PROPOSED HARTLEY ROAD ELECTRICAL SUBSTATION

Hartley Road and Cheechunk Road
Goshen, New York

FINAL ENVIRONMENTAL IMPACT STATEMENT

Hartley Road Lighting

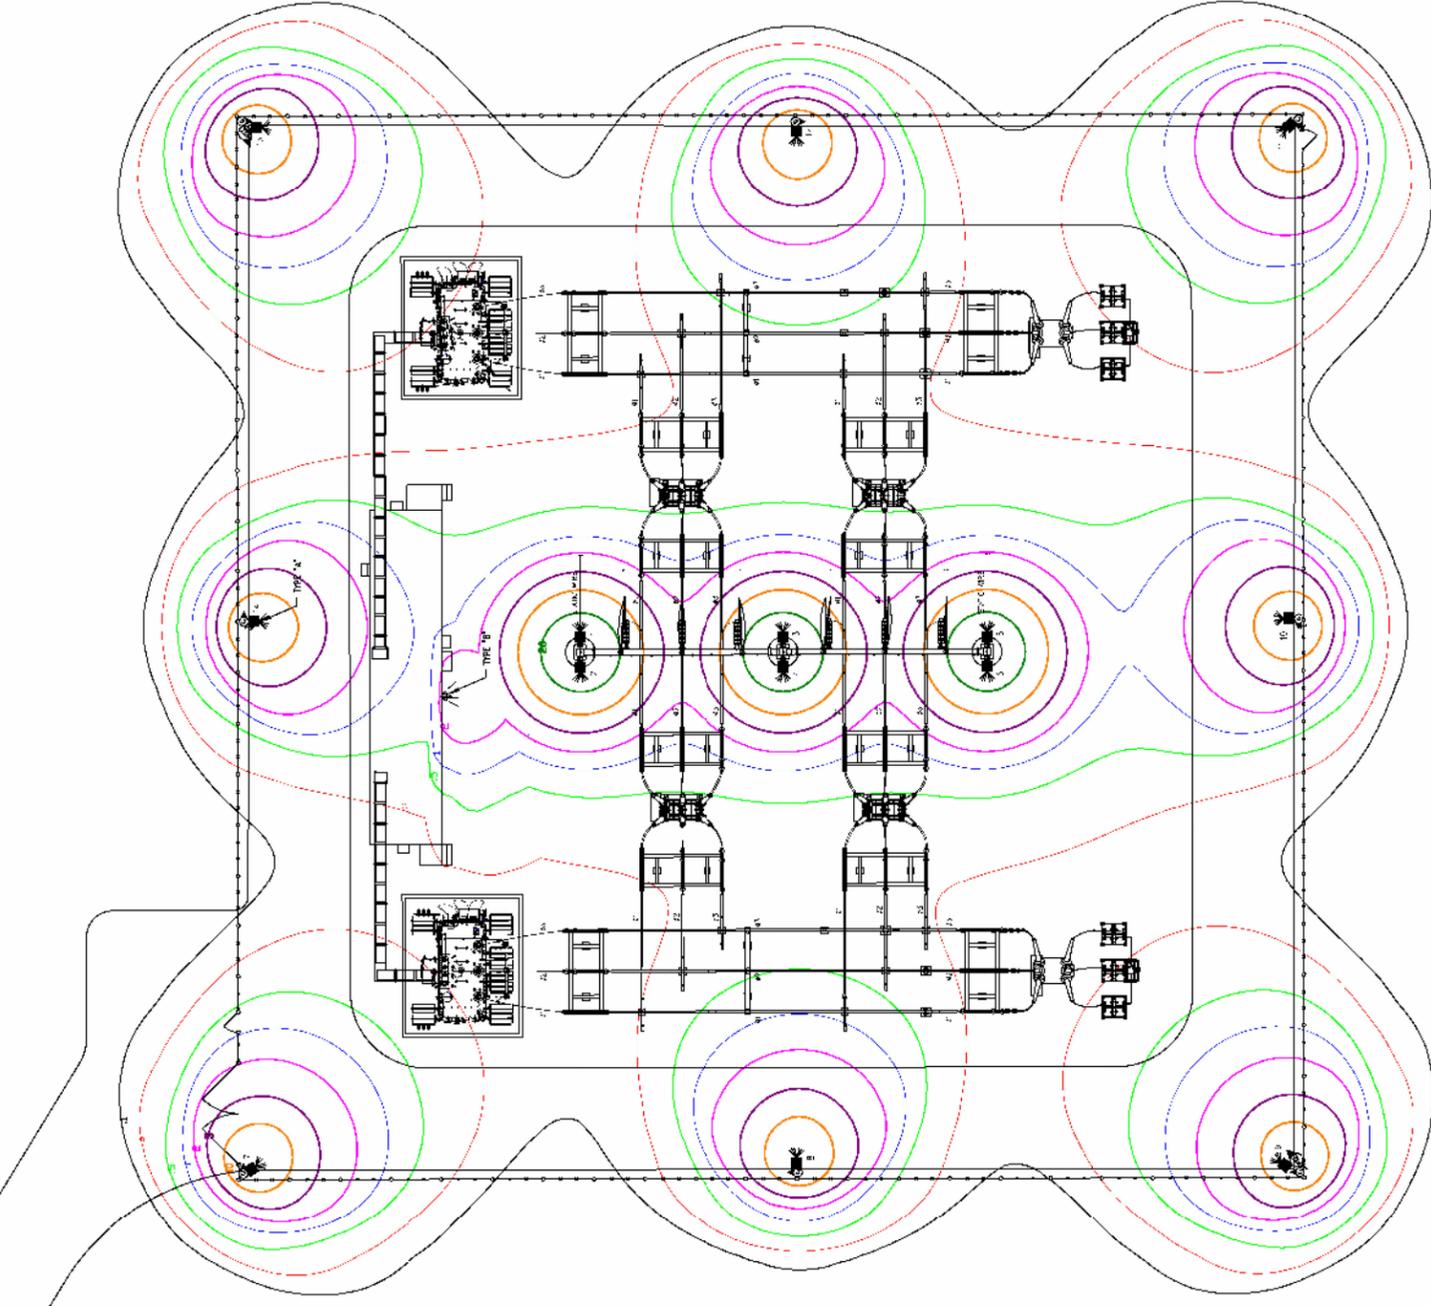
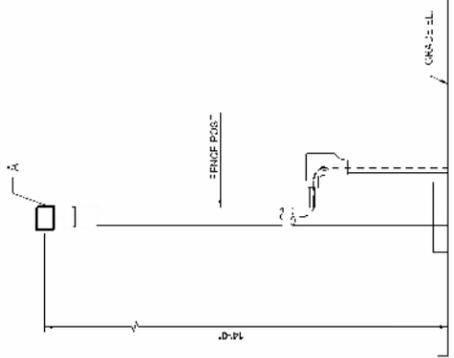
Public Comment 2: DEIS states substation will be predominantly unlit. Figure 6 shows approximately 15 light fixtures throughout the substation site while Figure 14 shows light levels surrounding the security fence to be approximately 0.1 foot-candles. FEIS should address the potential for offsite glare, confirm the specified fixtures are dark sky friendly and indicate how lighting will be controlled (timer, photocell, motion detector or other). (Riddick, 1/13/2012).

Public Comment 33: DEIS states substation will be predominantly unlit. Figure 6 shows approximately 15 light fixtures throughout the substation site while Figure 14 shows light levels surrounding the security fence to be approximately 0.1 foot-candles. FEIS should address the potential for offsite glare, confirm the specified fixtures are dark sky friendly and indicate how lighting will be controlled (timer, photocell, motion detector or other). (Riddick, 1/13/2012).
